- ISLAND AVENUE
109B-C-9

CLIFF ISLAND -

Memorandum from Department of Building Inspection, Portland, Maine

Island Avenue, Cliff Island—Construction of one story frame shed for fisherman's use (less than 200' from mean high water) for and by Earle R. MacVane—11/15/45

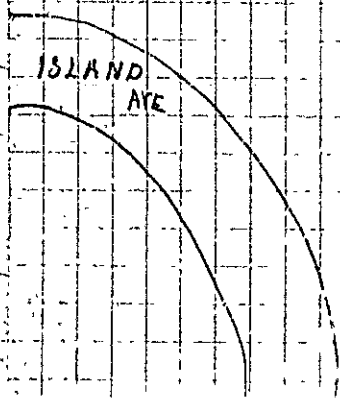
Concrete piers are required to be no less than 9 inches square or in diameter at the surface of the ground and no less than 10 inches square or in diameter at the bottom of the pier, piers to extend at least four feet below the finished surface of the ground where they are or to ledge if ledge is encountered at a less depth. Probably you have ledge rock at this location. It would be well to make sure that the piers have a flat "seat" on the ledge. Presumably the piers are to be spaced six feet from center to center under the center 4x6 under floor as well as under the sills.

RECENT
PURCHASES

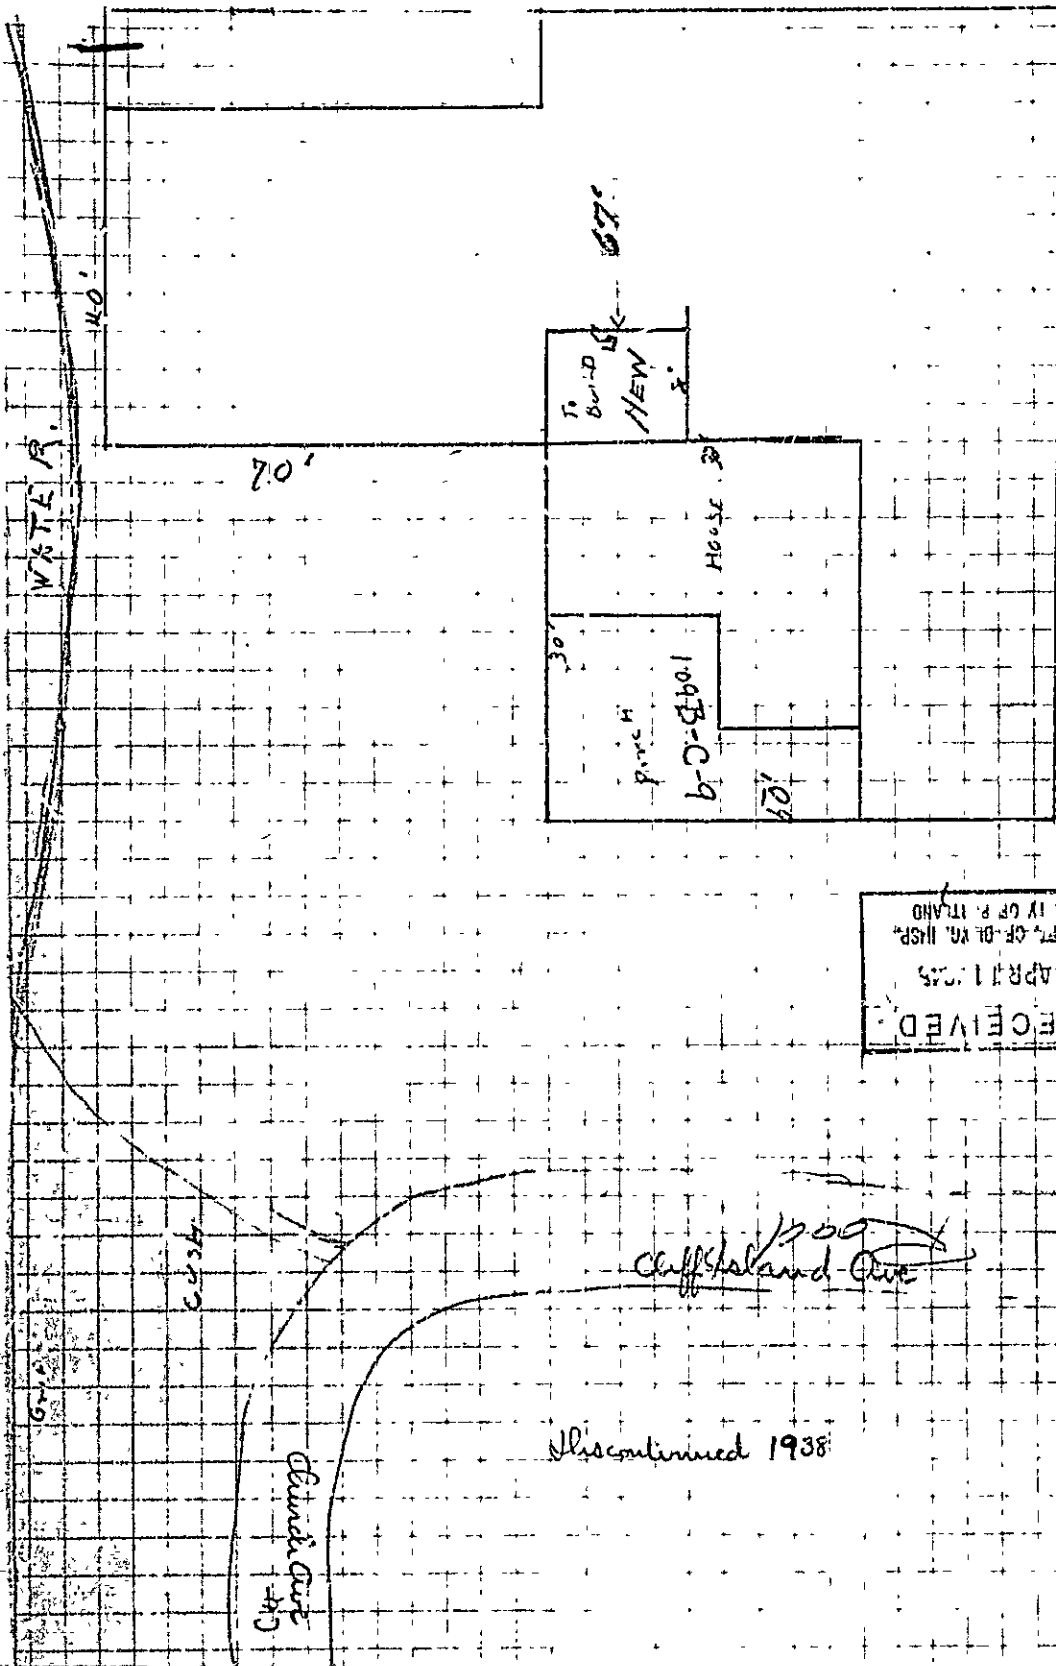
In your application for a building permit to cover construction of a one-story addition about 8 feet by 15 feet to your dwelling on Cliff Island, you have stated that the underpinning of the addition would be of wooden frame construction.

I am not allowed to issue a permit which includes an underpinning of wood since Section 306-c-4 of the Building Code provides that when a building of wooden frame construction is supported by foundation consisting of masonry walls, the part of the outside wall between the finished ground level adjacent to the wall and the under side of the sill shall be of masonry at least 8 inches thick.

Even though your present dwelling has a similar underpinning, I still would not be able to issue a permit for the underpinning of the addition to be of wood.

You would be permitted to use either a brick underpinning or a concrete block underpinning no less than 8 inches thick. If that is what you will plan to do, please write me a letter stating just what material you will use for the underpinning and how thick it will be, upon the receipt of which I will be able to issue the building permit.

In event that you are willing to provide the masonry underpinning and will write to me telling me so, the building permit will be issued, but I should think you would hesitate to build any addition until you are sure where your property lines are. As I understand it Island Avenue along your frontage has been discontinued as a public street, but presumably you must have some kind of a legal right of way to reach your house. It appears that you are unable to tell where your original property lines are and where the lines are of the property which you have purchased. If the building permit is issued, it will give you no right to go closer to the property lines than the Zoning Ordinance and the Building Code allow, these required distances to your property lines being 5 feet to a side property line and 12 feet to a rear line. I should think that that you would exhaust every effort in trying to find out just where the limits are of the property you own.
